Wollongong Local Planning Panel Assessment Report | 20 April 2021

WLPP No.	Item 3
DA No.	DA-2020/1292
Proposal	Mixed use development
Property	40-46 Crown Street WOLLONGONG
Applicant	ADM Architects
Responsible Team	Development Assessment and Certification - City Centre Major Development Team (BH)

ASSESSMENT REPORT AND RECOMMENDATION

SOUTH ELEVATION
CROWN STREET ASPECT

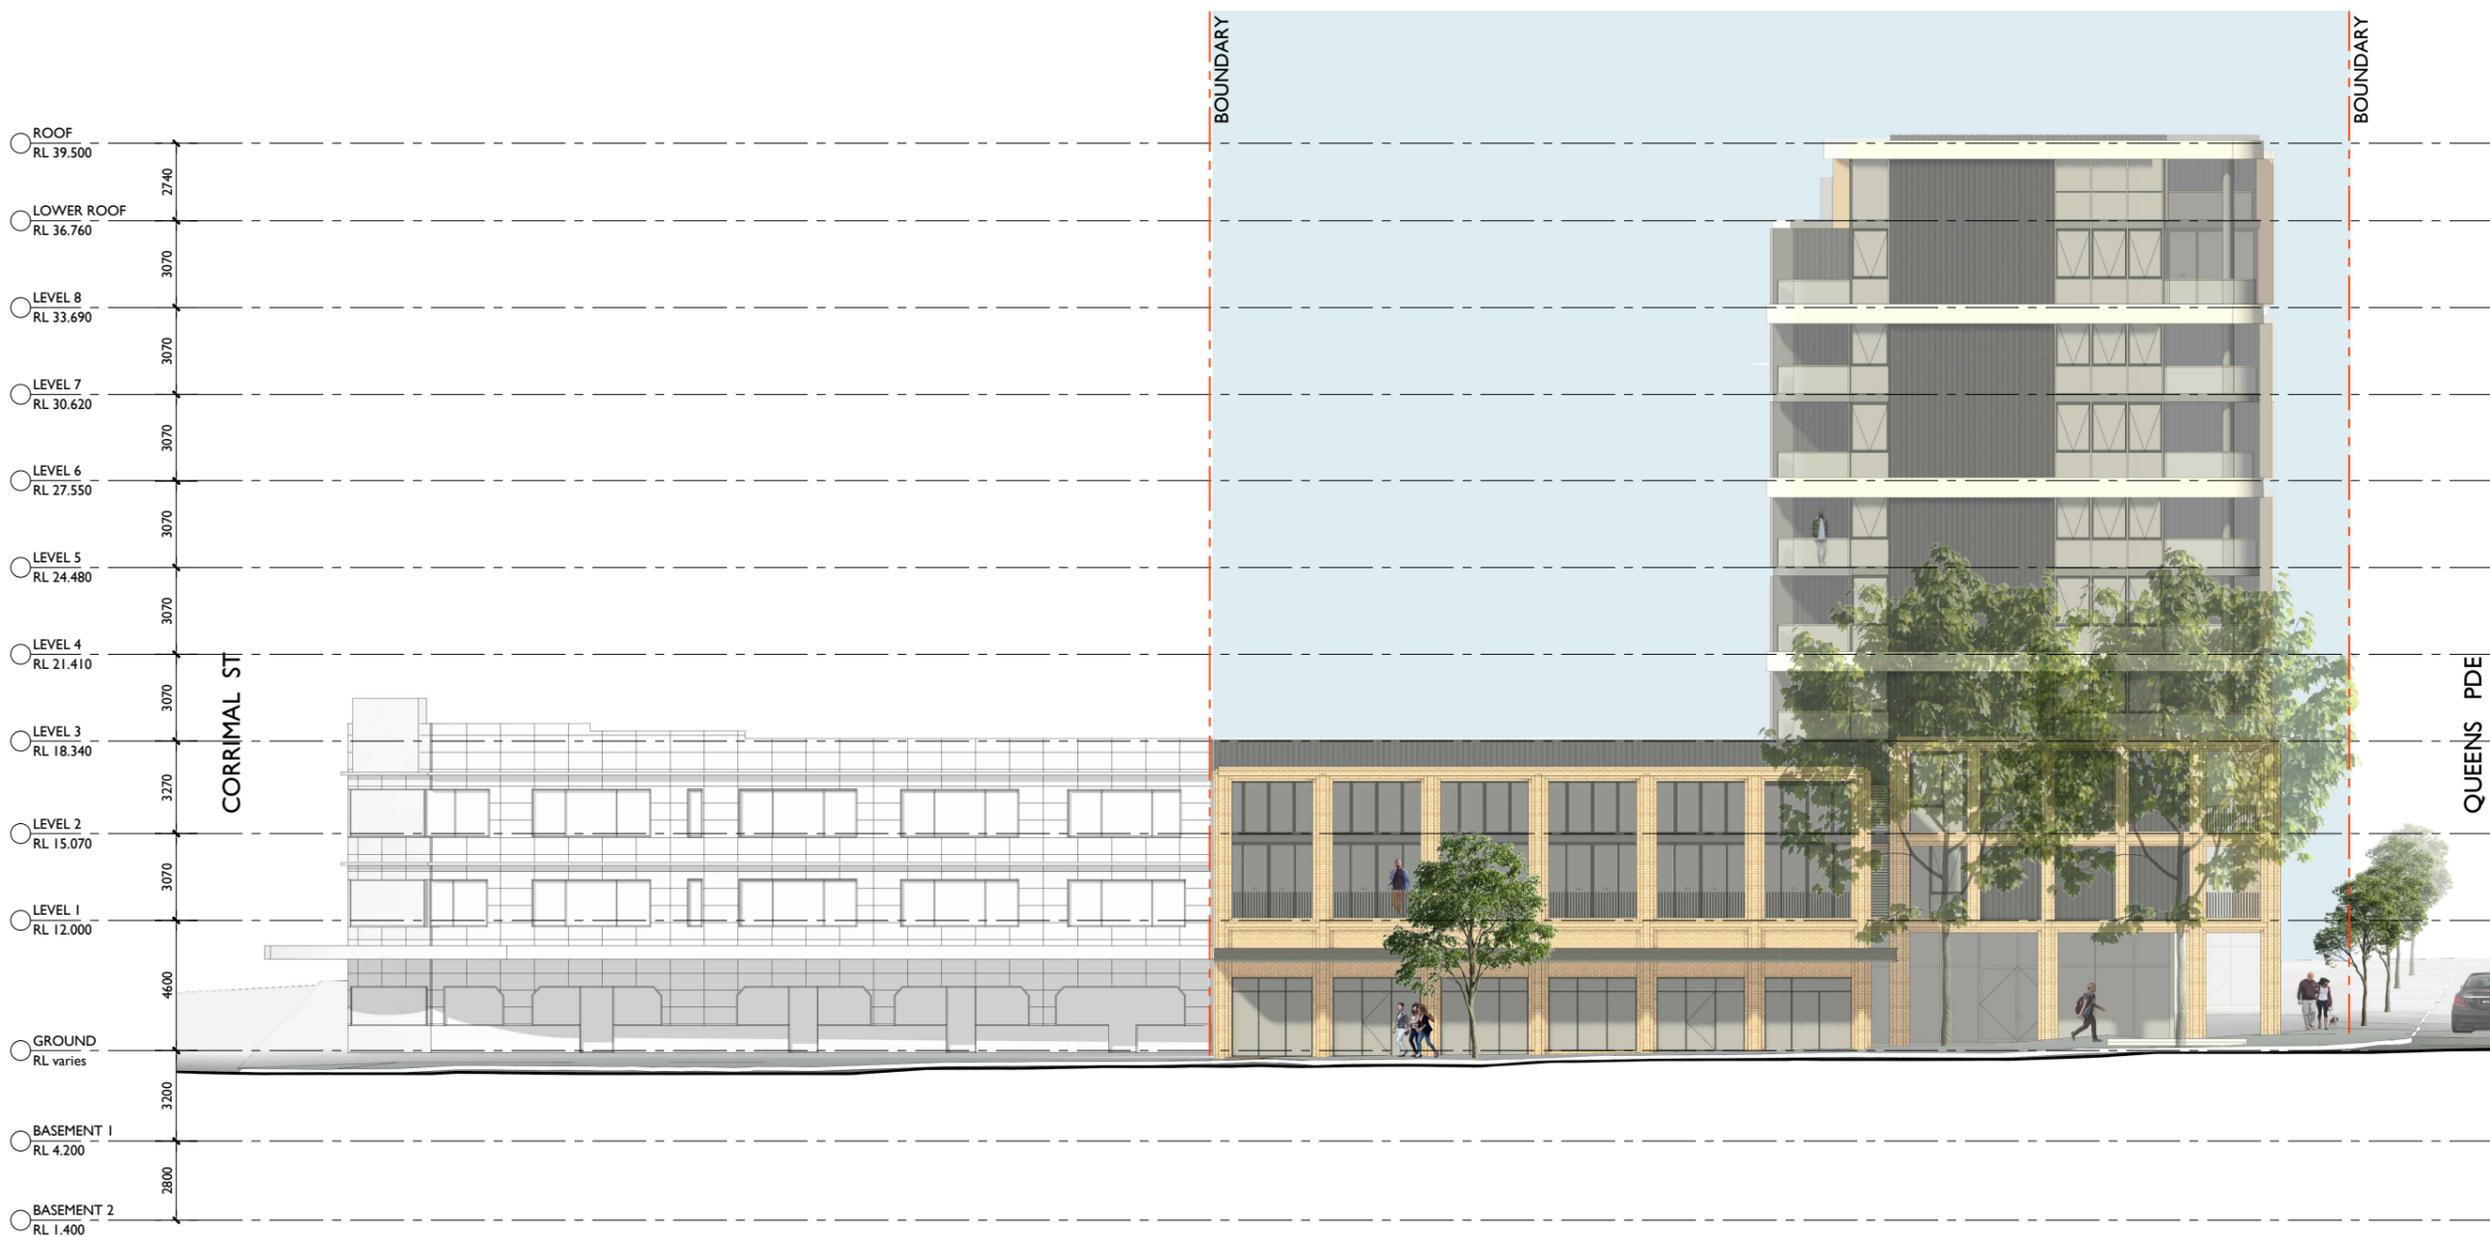
Discussions with Council's Landscape Architects to determine what street greening may be possible west of the existing street trees is encouraged. It is noted that two trees are shown west of the existing trees south elevation A-202 but these don't appear on the Ground floor plan or the landscape plan.

REPOSE: Refer response by DSB Landscape Architects .

Title		
DEVELOPMENT APPLICATION PART SECTION AWNING INTERFACE		
Scale	Date	
1:100 @A1 1:200 @A3	MARCH 2021	
Drawn	Checked	
LGD SJ	ADM	
Project No.	Drawing No.	Issue
2018-45	A-208	A

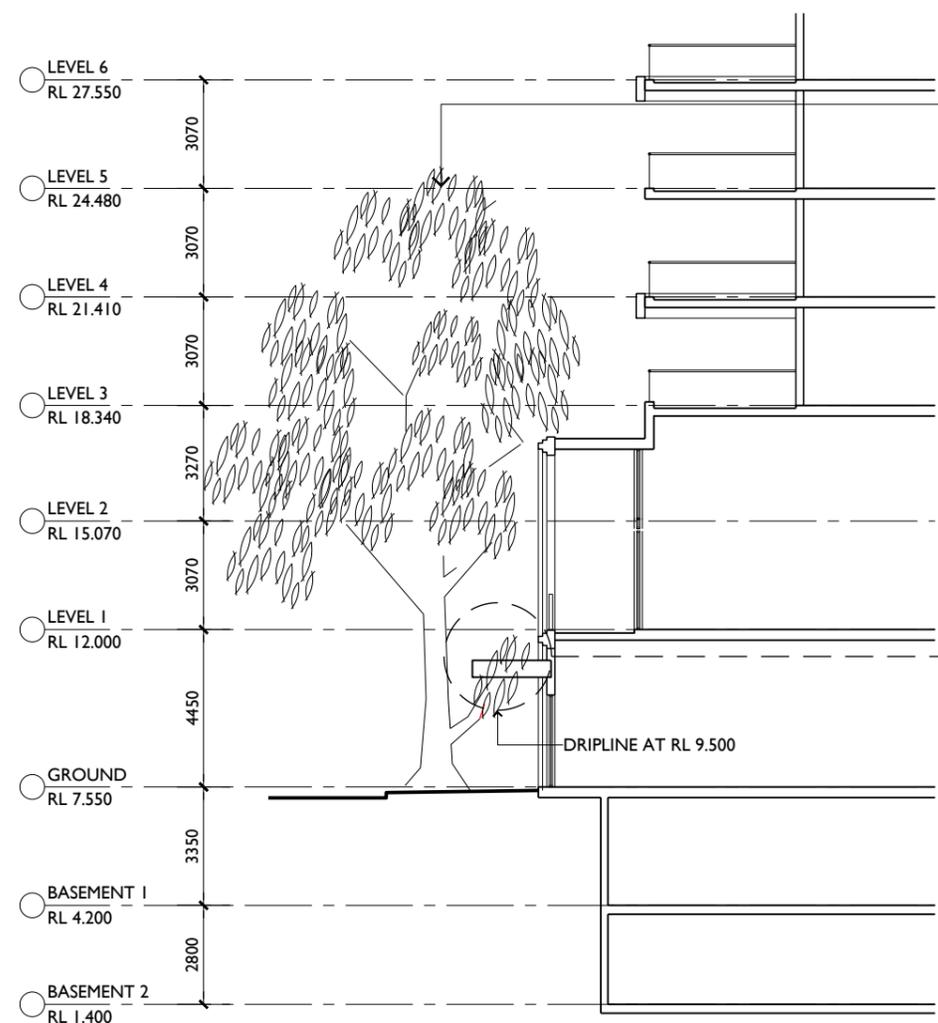
It would appear the proposed awning on Crown Street conflicts with the canopy of the existing street tree numbered and described as tree 1 in submitted Arboricultural Impact Assessment. It is requested that the proposed awning be modified to ensure the preservation of the majority of the canopy of trees 1 and 2.

RESPONSE : Additional survey of the bottom branches of the trees has been undertaken. The branches in question are regrowth from a precious cutting that the arborist includes in his report could be pruned. The pruning of these small branches would allow the awning to be maintained. Refer architectural awning section drawing A-208 which includes a photo of the branches in question.
